BEFORE THE HEARINGS PANEL FOR THE QUEENSTOWN LAKES PROPOSED DISTRICT PLAN

IN THE MATTER of Hearing Stream 8 –

Business Zones

MEMORANDUM OF COUNSEL ON BEHALF OF THE QUEENSTOWN LAKES DISTRICT COUNCIL REGARDING THE QUEENSTOWN TOWN CENTRE RECOMMENDED CHAPTER

Pedestrian Link Map (Figure 1) on pages 23 and 24 of recommended chapter

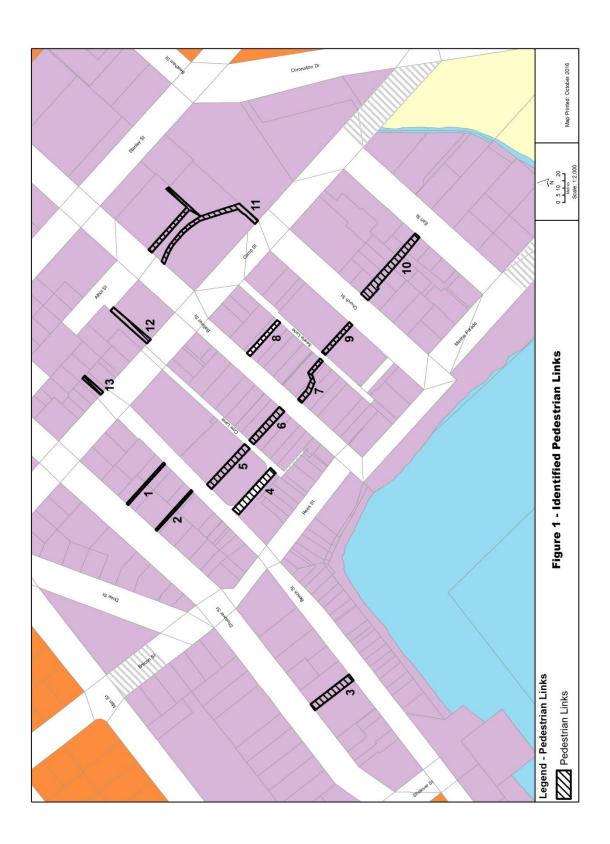
- 4. Following the filing of the Section 42A report, further work has been completed to update the Pedestrian Link Map at Figure 1 of the recommended chapter. This work was unable to be completed before finalising the s42A report on 2 November 2016 due to time constraints on Council's Geographic Information Systems (GIS) team.
- **5.** The updated Figure 1 replaces both of the maps on pages 23 and 24 of the recommended chapter.
- 6. The update to Figure 1 results in the need for a consequential amendment to Rule 12.5.8.3 in the recommended chapter, as follows:
 - (a) the addition of a new item 13 "Camp St/ Athol St carpark (Sec 18 Blk V TN OF Queenstown)"
- **7.** The submission source for these changes is 238 (NZIA).
